RE: Parker and Pine F1 L1: In-N-Out Burger
Formal Site Plan Application – 1st Submittal Review Comments – SUB22-063
Fire & Life Safety

Plan Review Summary:

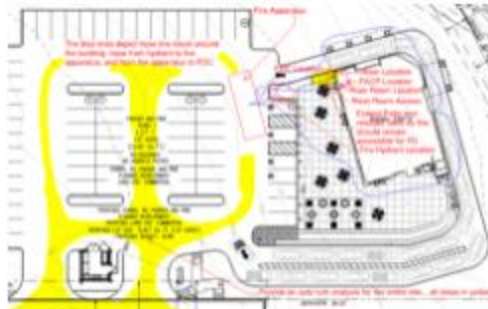
6. A sidewalk shall be extended to the riser room door as well as the FDC; a 5'x5' pad shall be provided in front of the FDC. Address this issue when resubmitting.
[Response: The concrete patio encompasses the riser room to satisfy this comment. Please clarify if additional changes are required.](#)
7. Utility Plan Set: The applicant shall provide a utility plan that identifies the locations of all utilities on the site (including natural gas and electricity). The overall utility plan shall identify the location of the required fire hydrant(s) and the required underground fire line (UFL). The plan set shall identify the UFL on the plan (not just providing a note) while providing the length

and diameter of the UFL (as measured from the T at the water main to the flange within the building. Address this issue on the plan set when resubmitting. Note – The UFL shall have its own tap; domestic water and the required fire hydrant shall have separate taps.

Response: Sheets WS1.0-Overall Utility Plan, and WS3.0 – Water Plan, of the PWSD CD set include the requested information. Please advise if additional information is required.
